Date: 07/21/2023 RFB No: **2023-043**

Commodity: North Interceptor Wastewater Improvement Phase 1 Project

Addendum No: 4

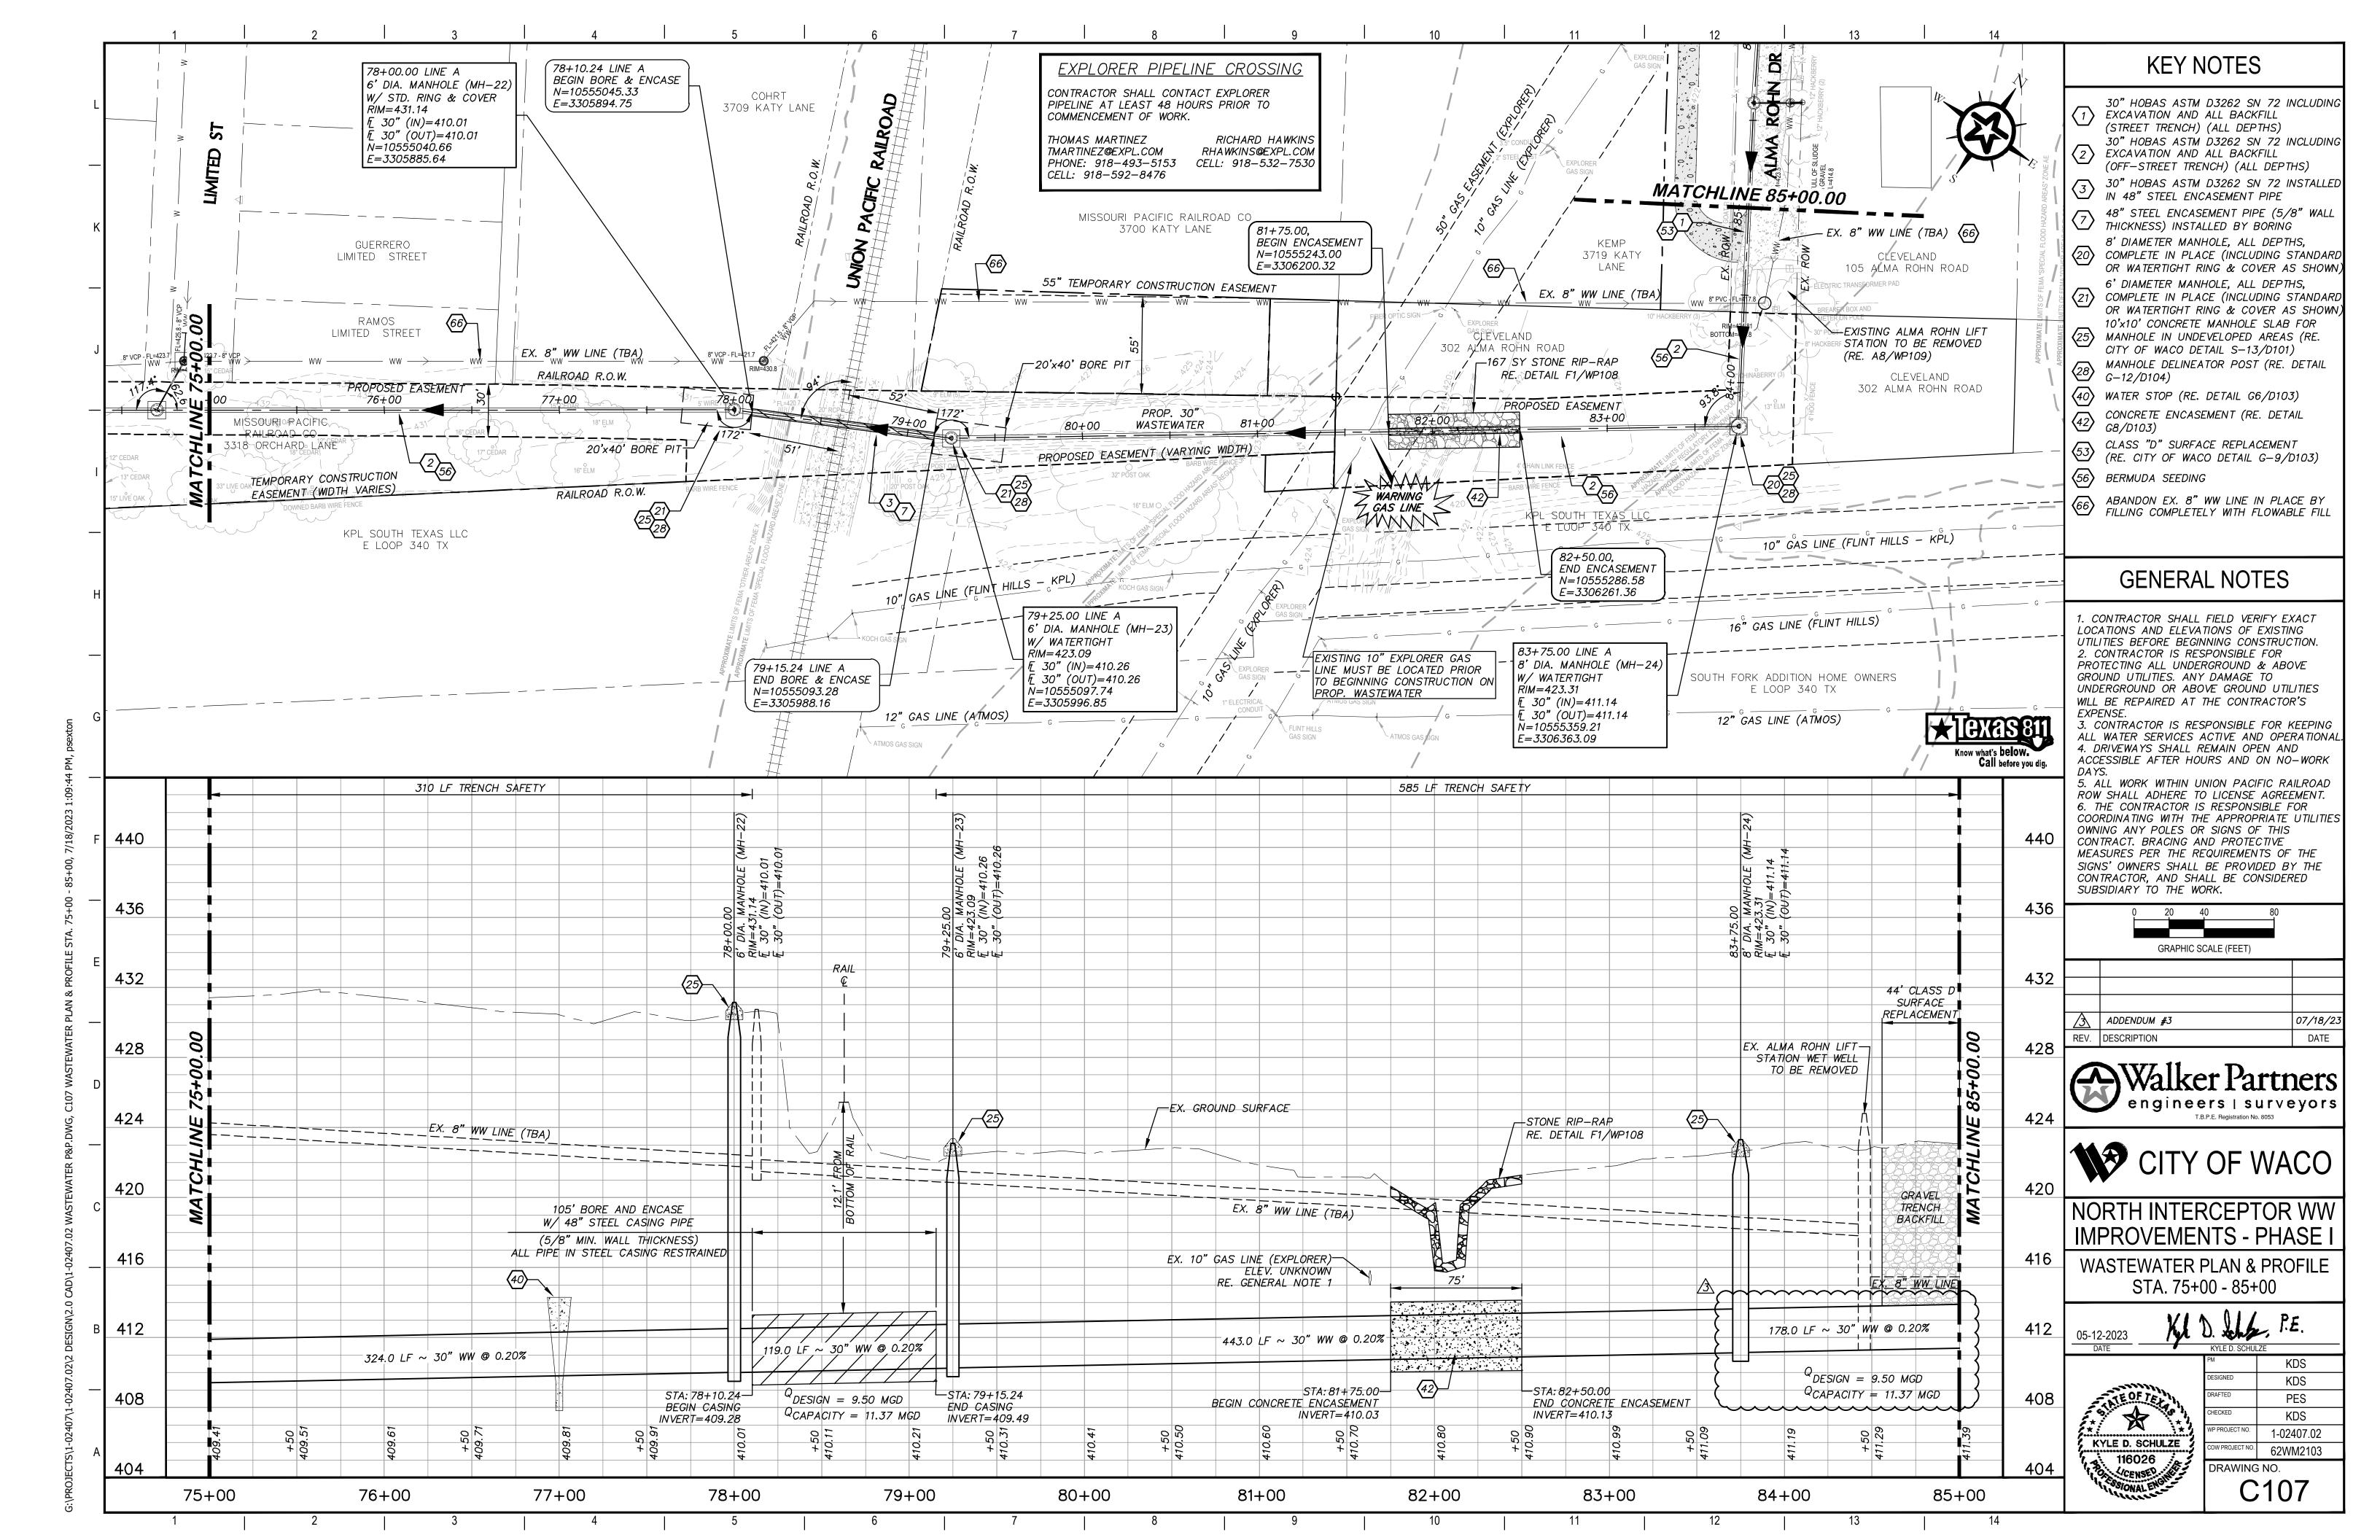
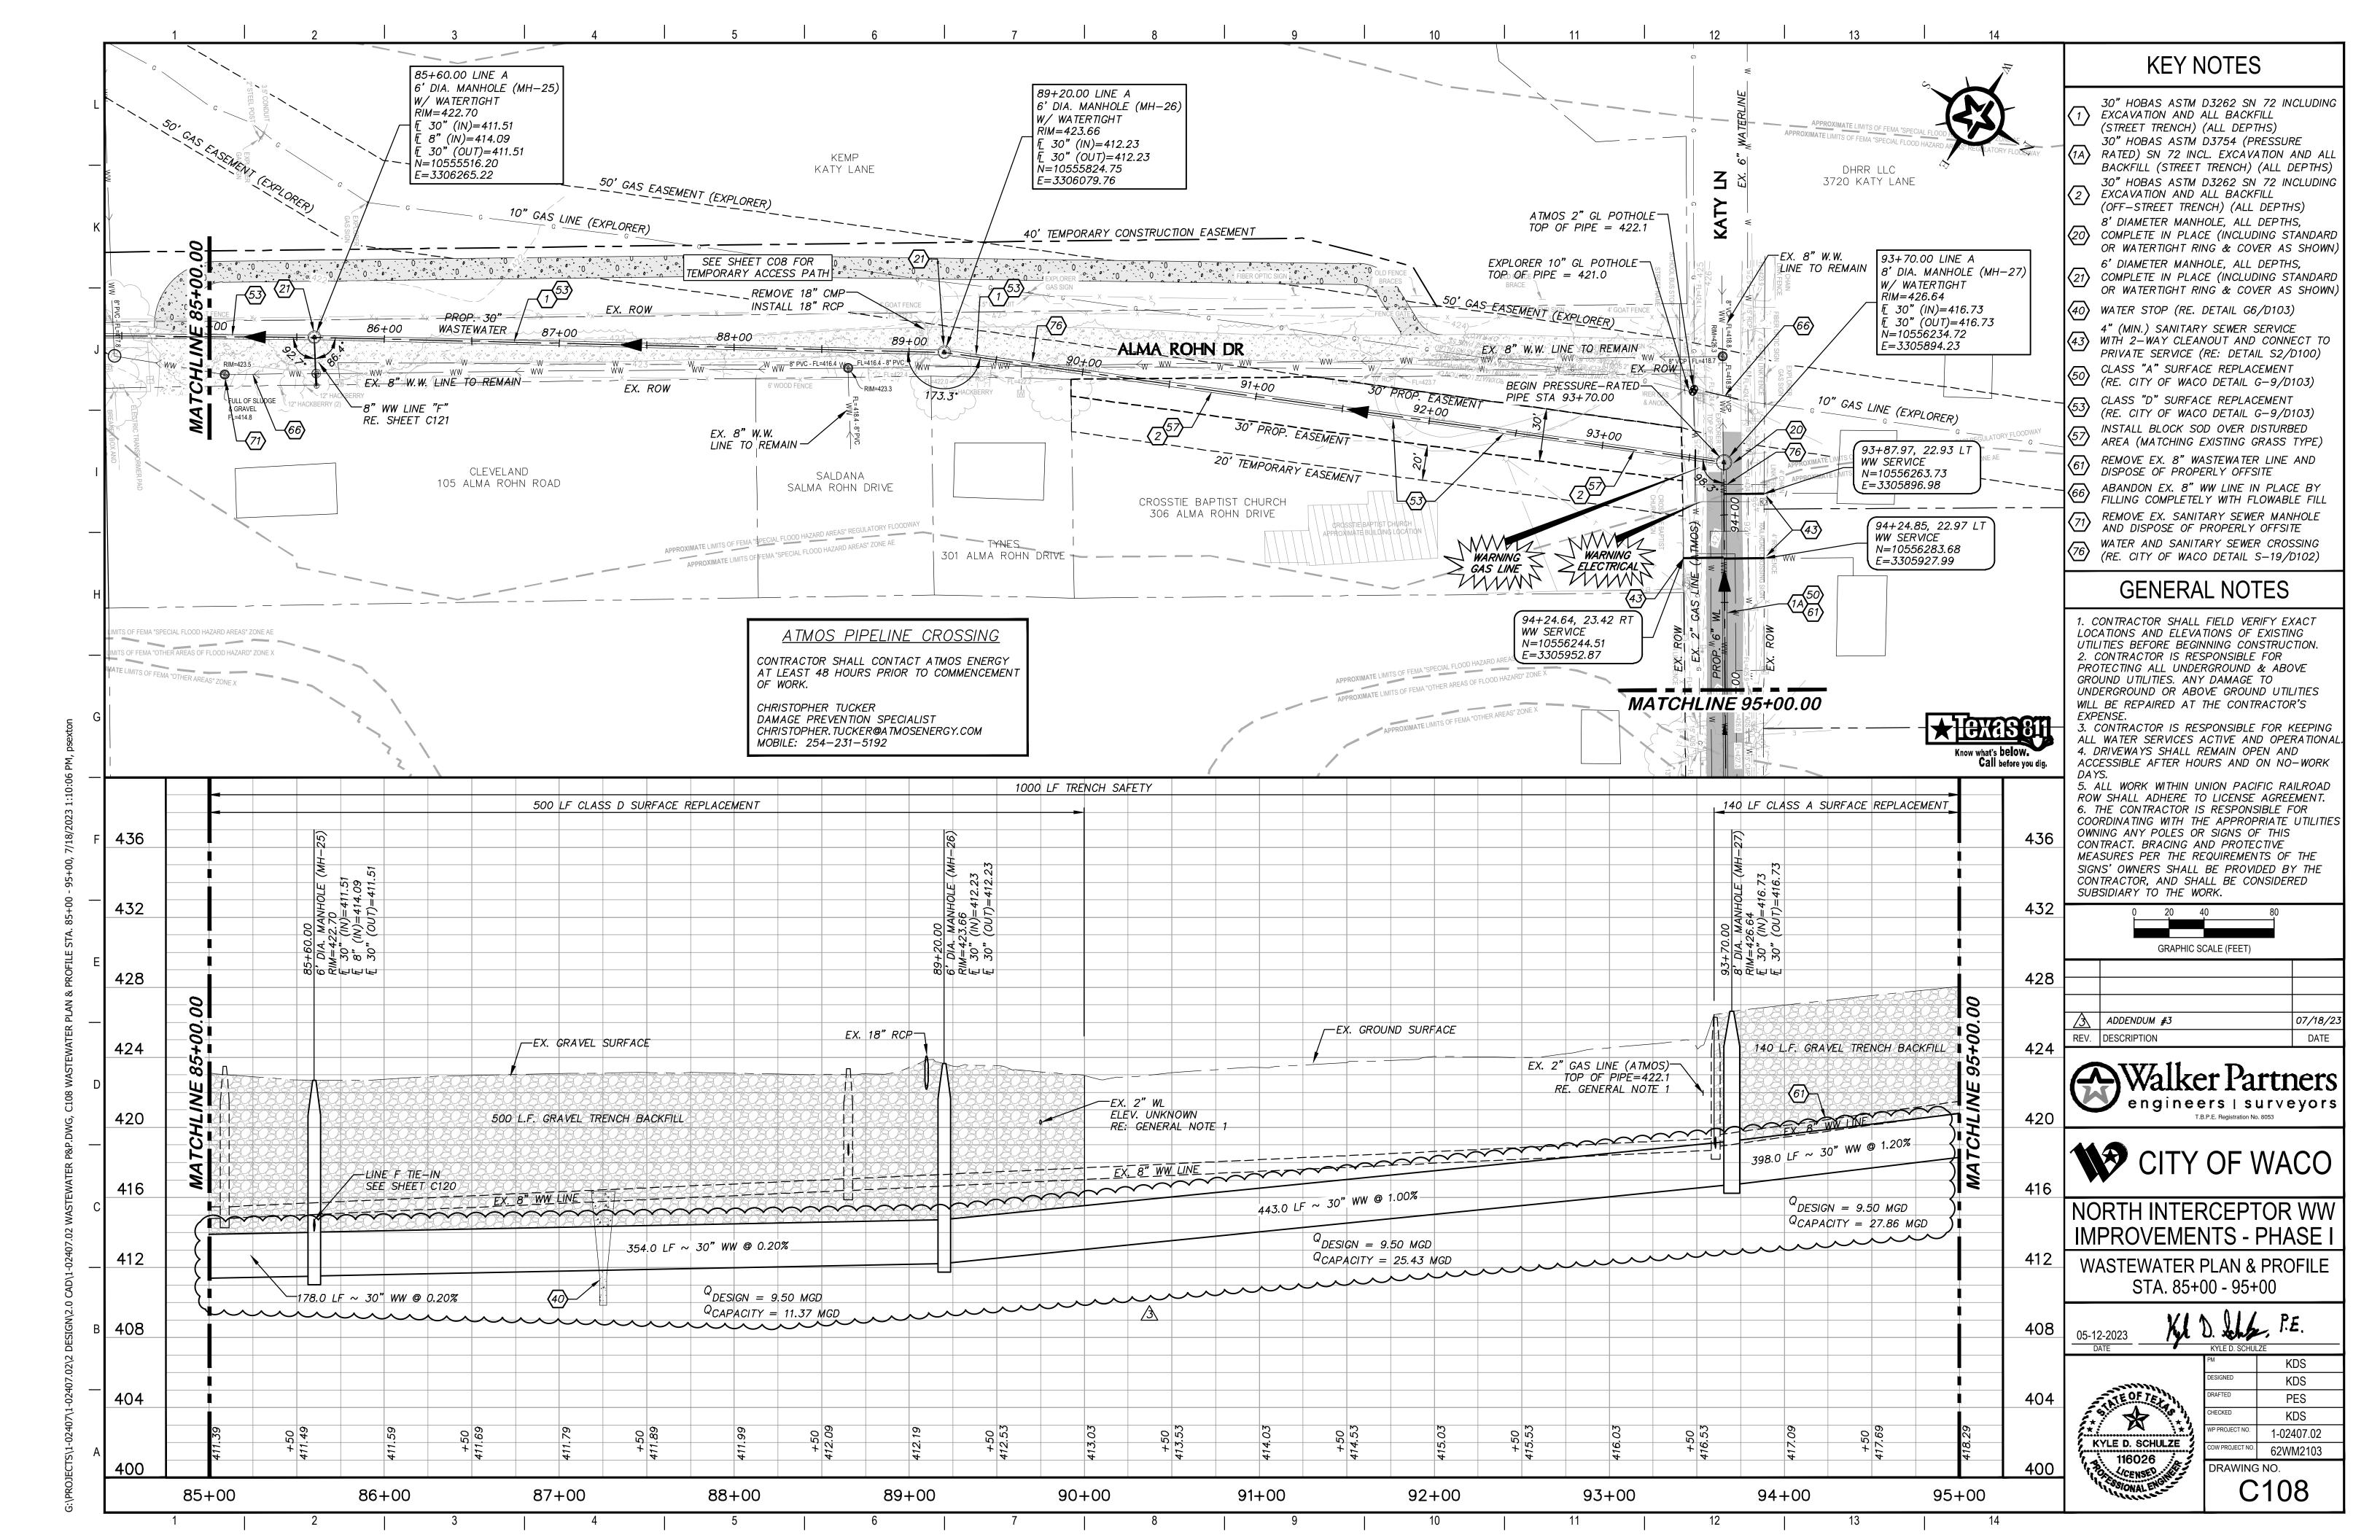
Can we assume that existing force main lines (16" & 8") can be isolated independently to facilitate the tie-over? Meaning, can the 8" force main handle all the flows for a short period of time?

The existing 16" force main at Williams Road is not currently in use. The existing 8" force main is active and conveys all the flow from the lift station. The two existing force mains combine into one 16" force main approximately 1,200 LF west of Williams Road near intersection of Texas Street and Highway 84. The 16" force main west of Texas Street is active and carries all flow from the lift station. City Record Drawings are attached for reference.
